**PLANNING AND ZONING ADVISORY BOARD AGENDA
ADVISORY/ COMMITTEE BOARD MEETING
Village Hall Council Chambers
226 Cypress Lane
Palm Springs, FL 33461
Tuesday, January 28, 2020
6:30 PM**

6.1 Ordinance No. 2020-04 - Land Use Plan Amendment (Large Scale) - 2085 South Congress Avenue and 3243 Lillian Road (Proposed Palm Springs Residences Residential Planned Development)

7.1 Resolution No. 2020-04: Residential Planned Development Site Plan (SPR20-02) and Two (2) Waivers, and Sign Variance (PSV20-01) - Palm Springs Residences - 2085 South Congress Avenue and 3243 Lillian Road (Quasi-Judicial Hearing)

SUBJECT: Large-Scale Land Use Amendment and Site Development Plan (Residential Planned Development Site Plan with Waivers) and Sign Variance - Palm Springs Residences – 2085 S Congress Ave and 3243 Lillian Rd

PROJECT:	1903-21
SHEET:	SP-1

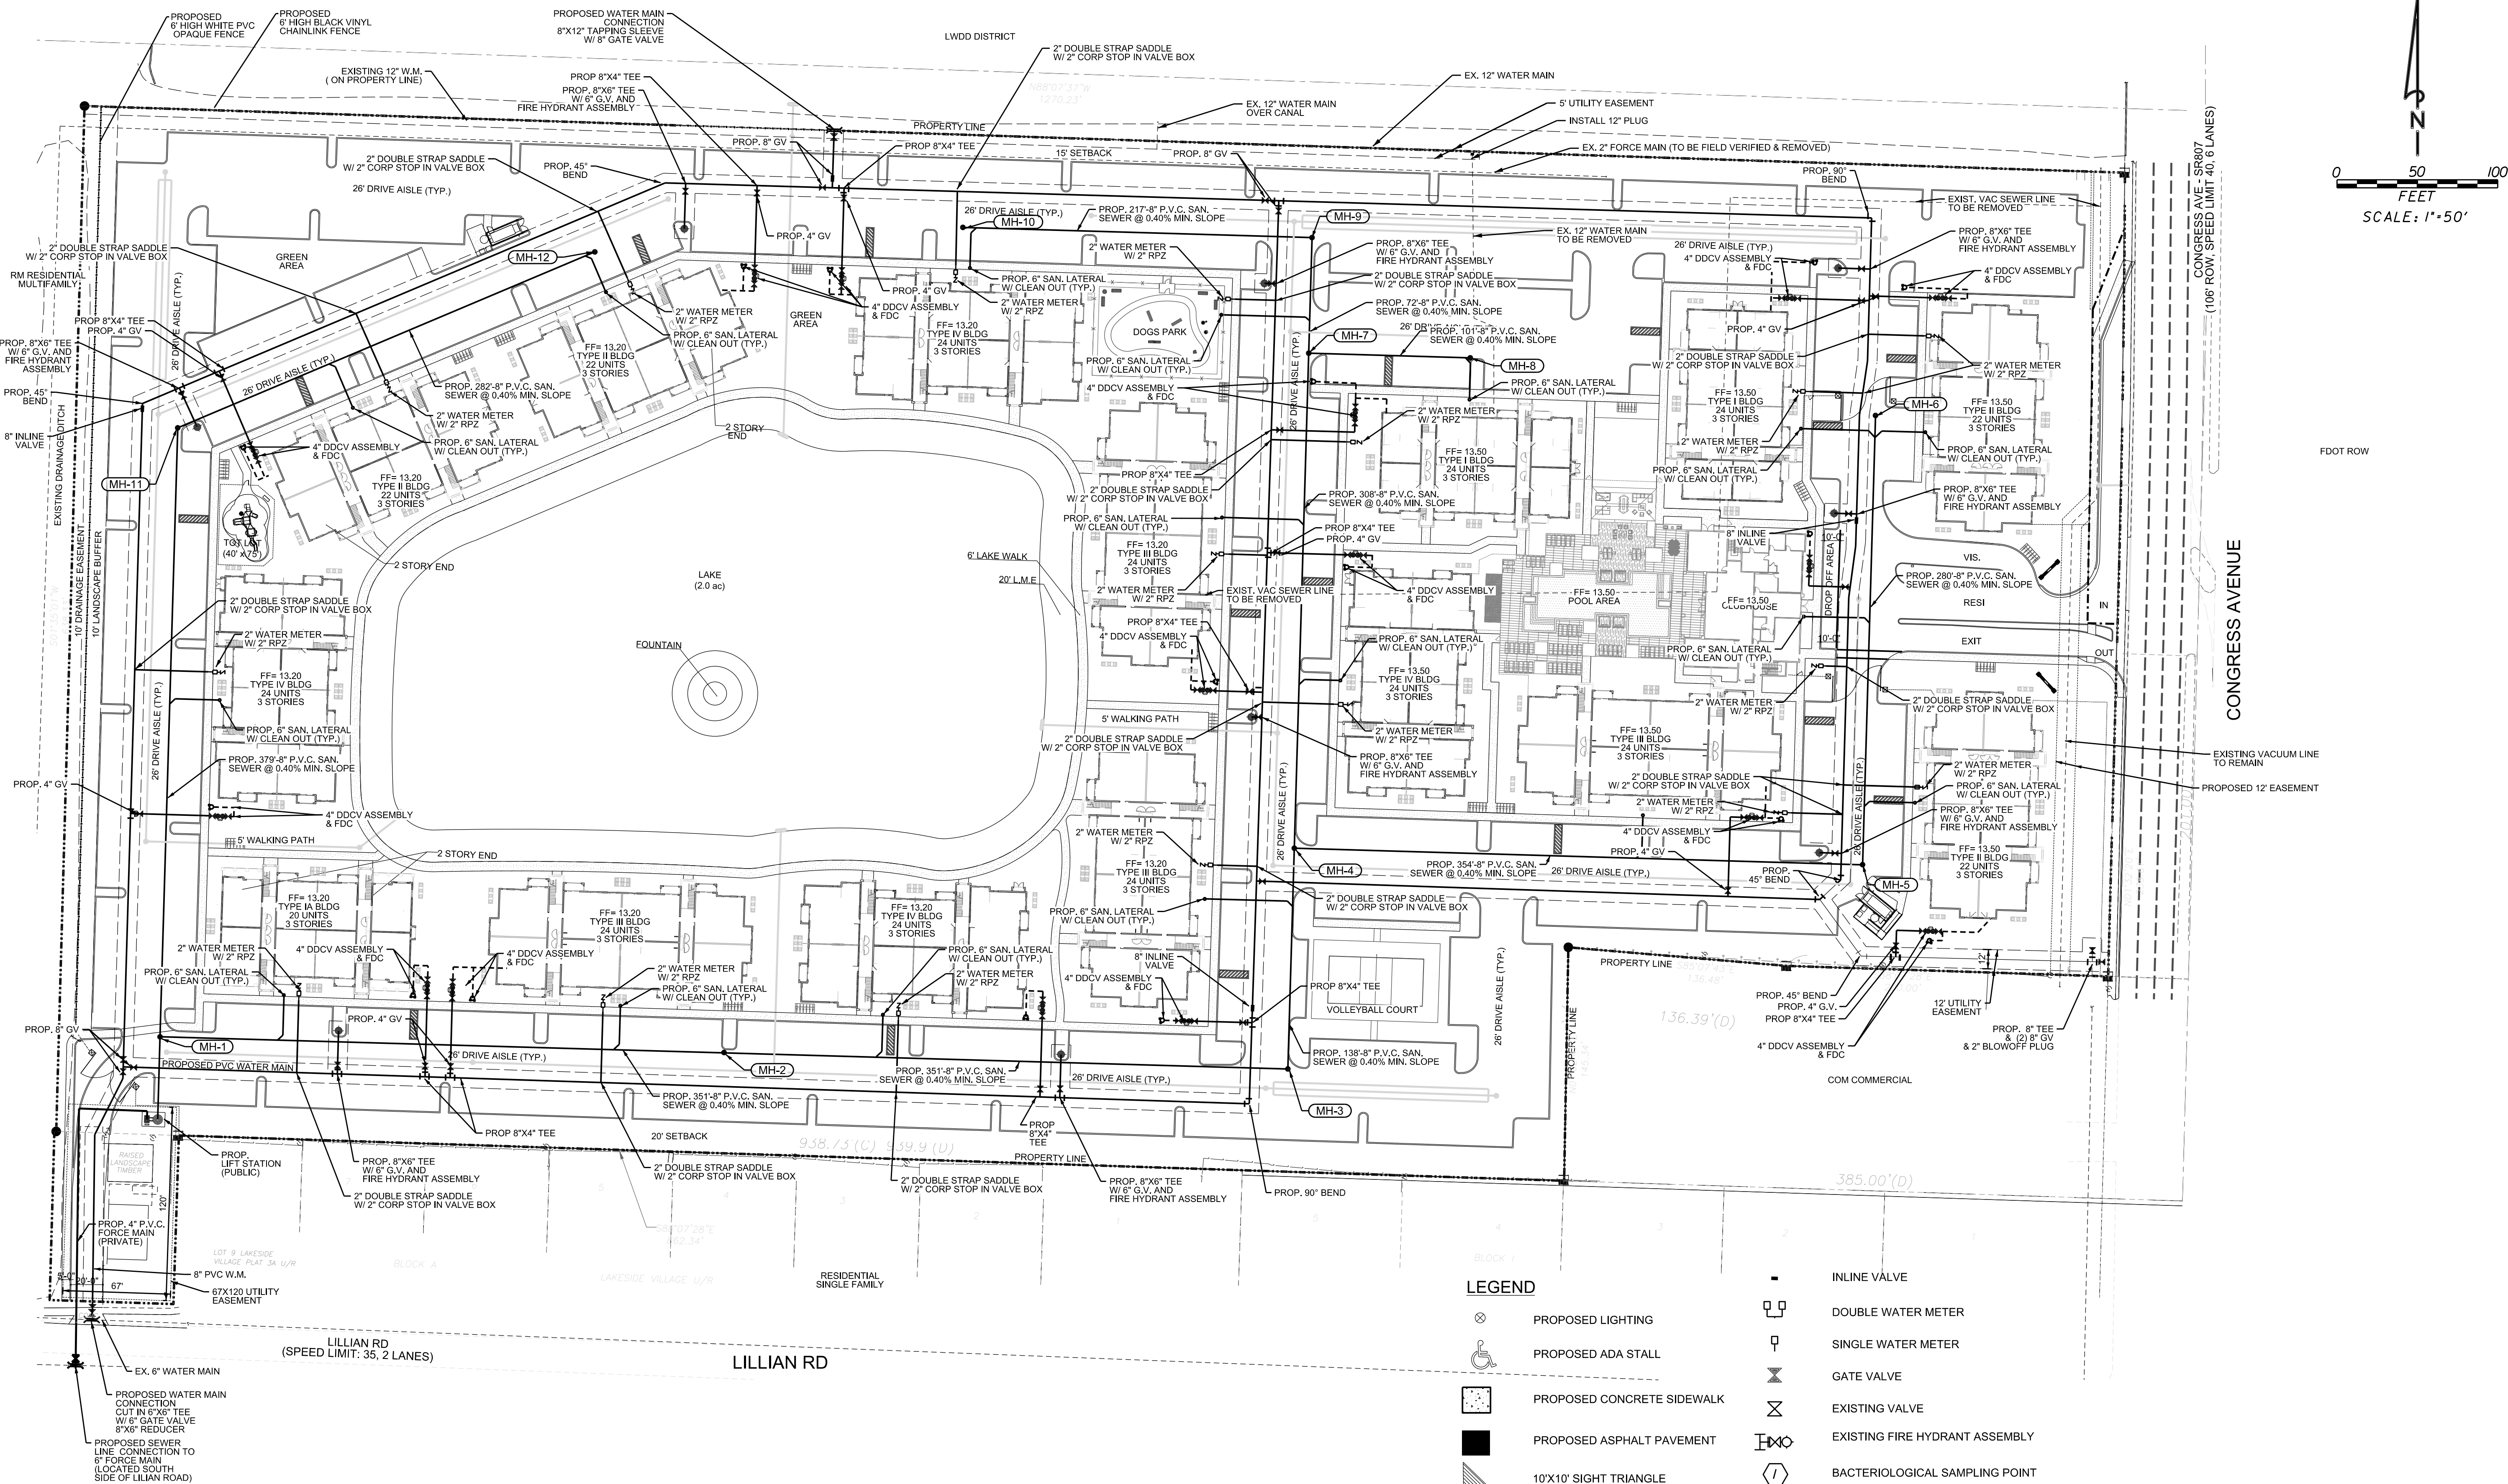
1. Per Site Plan (SP-1),
 - a. The proposed 6-ft white PVC opaque fence along the west property line runs up to the north property line, which blocks cross access to the drainage easement and utility easement. Provide a gate.
 - b. The ditch along the west property line runs to the south property line. The top of bank shall be relocated along the entire west property line as well as the 10-ft drainage easement.
2. Per Landscape Plans, Sheets L-211 & L-212, there shall be no trees within the 10-ft drainage easement along the west property line.

PROJECT: 1903-21
SHEET: FT-1

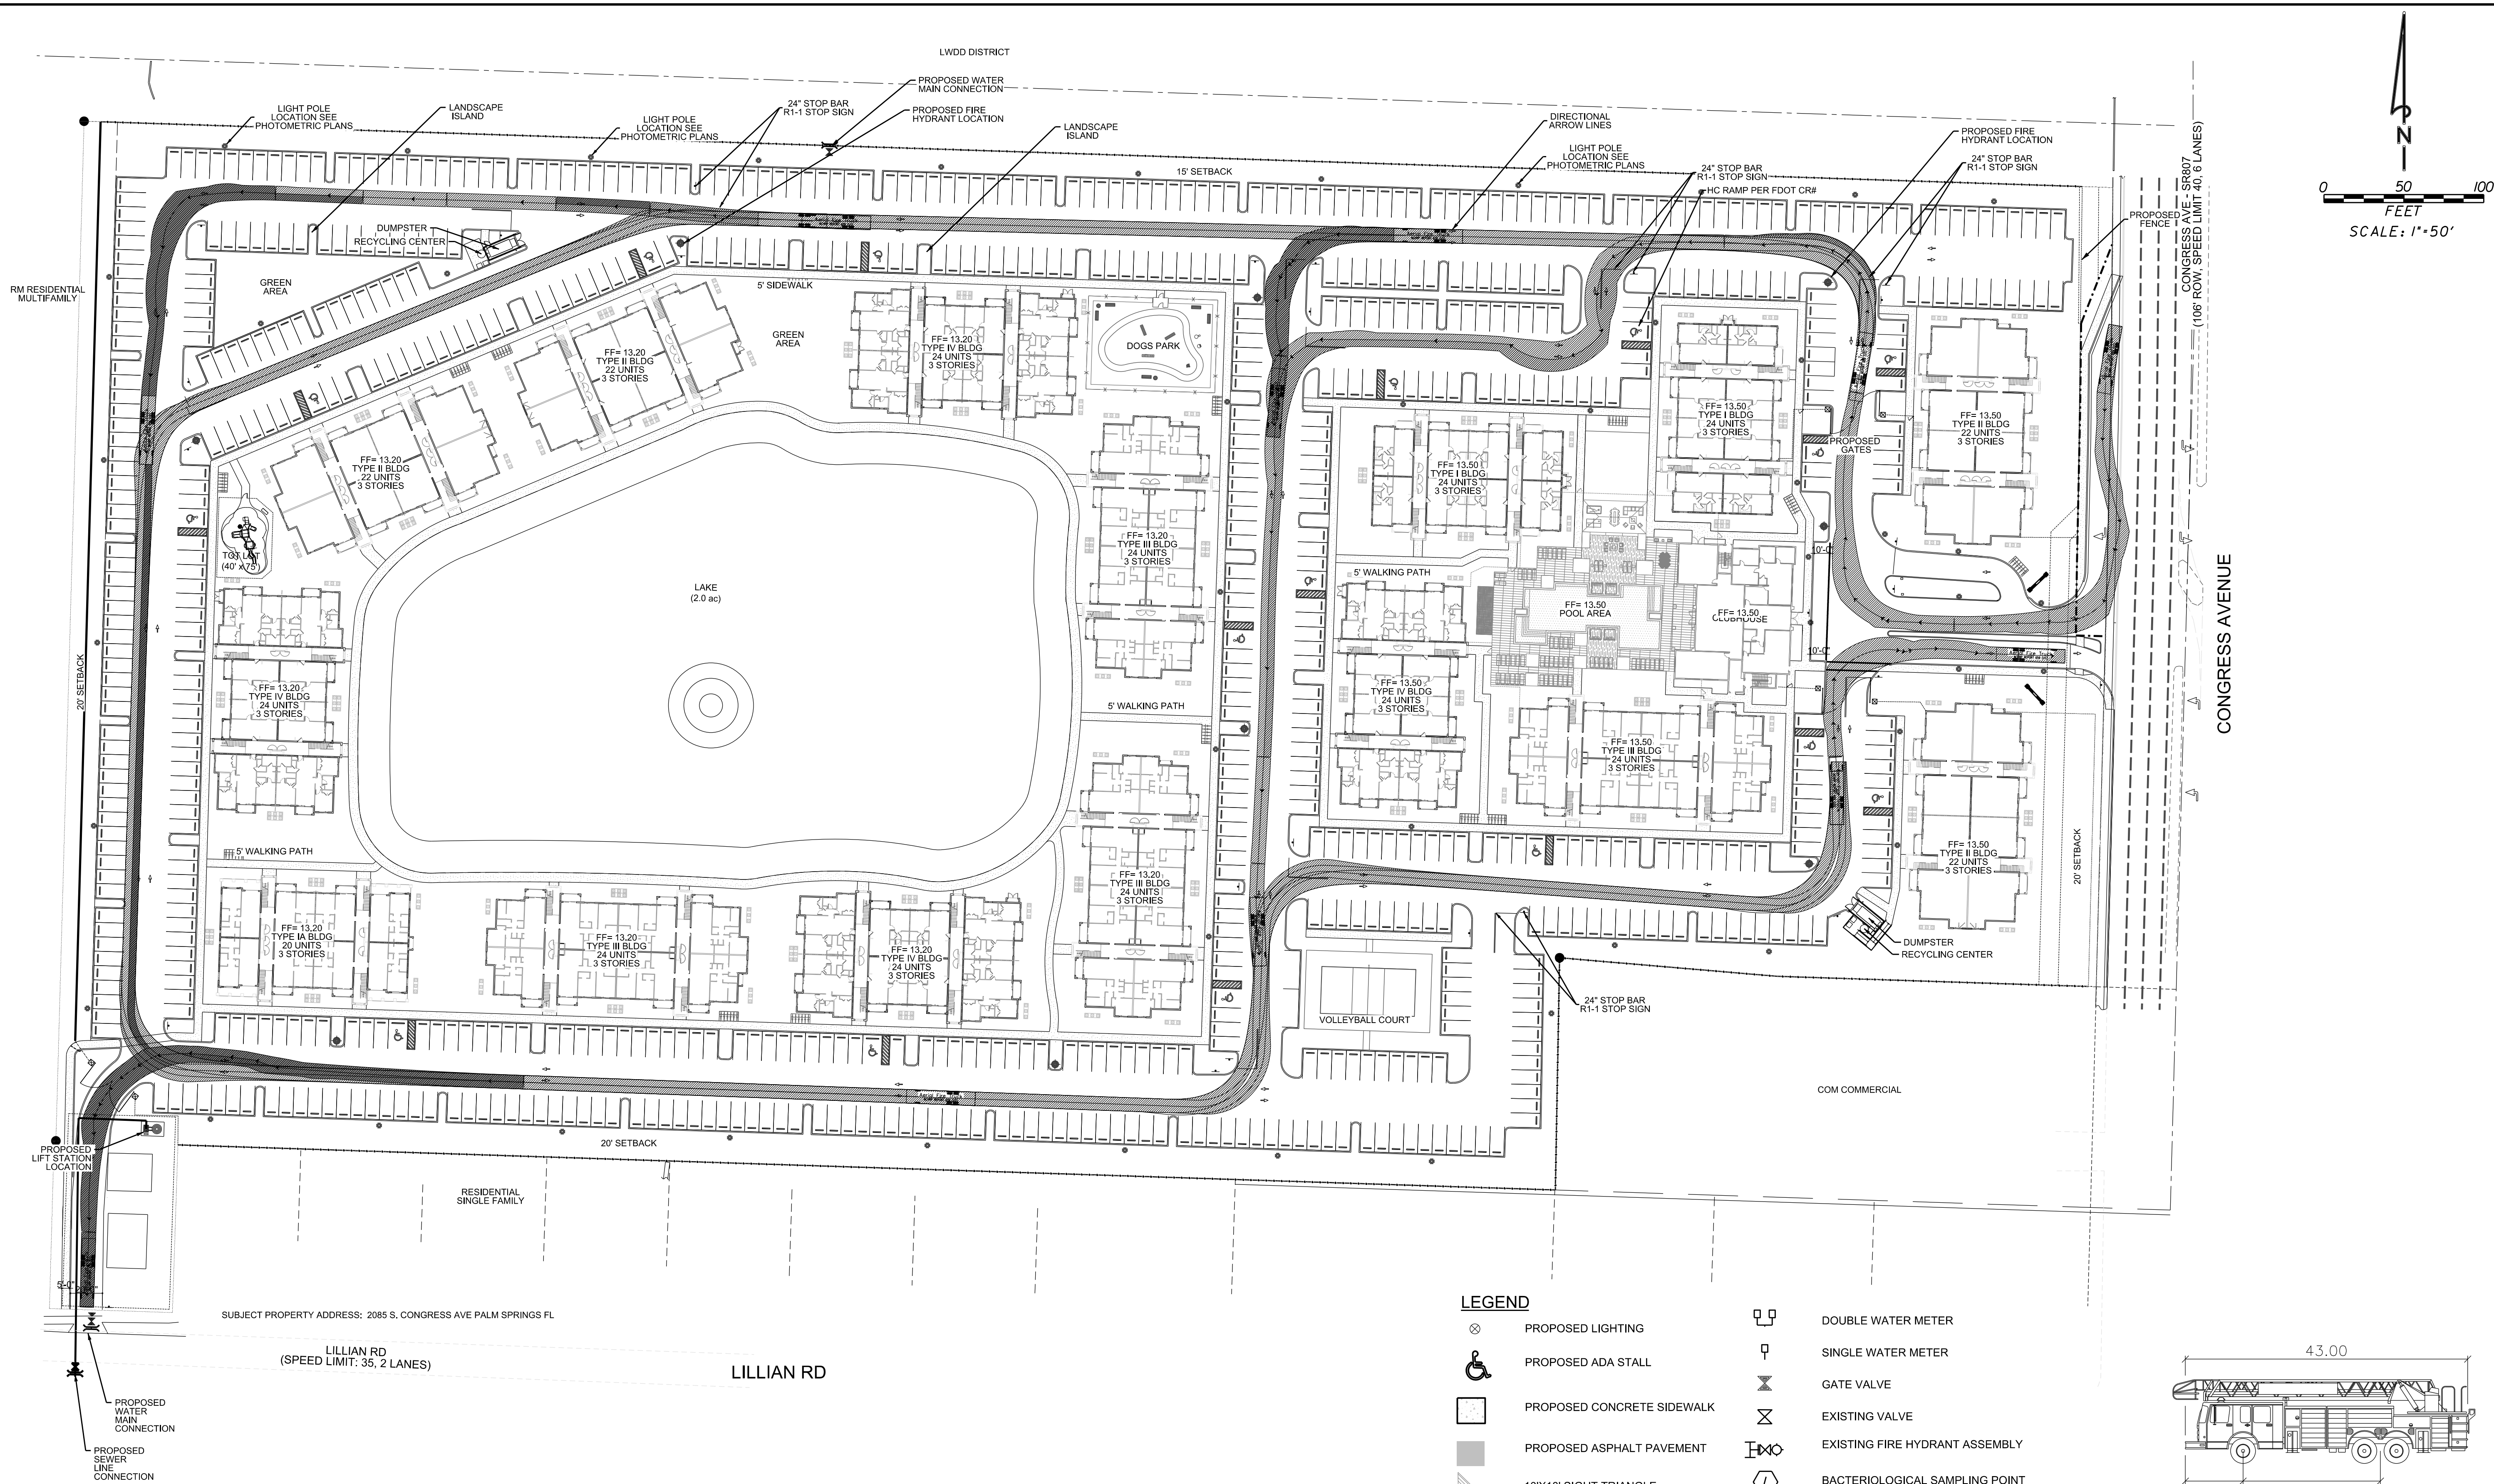
<u>Page</u>	<u>Comment</u>	<u>Code</u>
~~SP-1~~	~~The swing gates must both swing in the same direction. The truck modeling on sheet FT-1 shows the fire apparatus crossing the traffic divider line to make the turn to exit the site. This is not an acceptable turning radius. You will have to discuss your options when you submit the civil plans to the Water Officer.~~	
~~SP-1~~	~~A Knox key switch is required at each set of gates for fire dept. access.~~	
~~WS-1~~	~~The clubhouse must have an automatic fire sprinkler system installed.~~	~~PBC Fire Code 13.3.1.1.1(4)~~
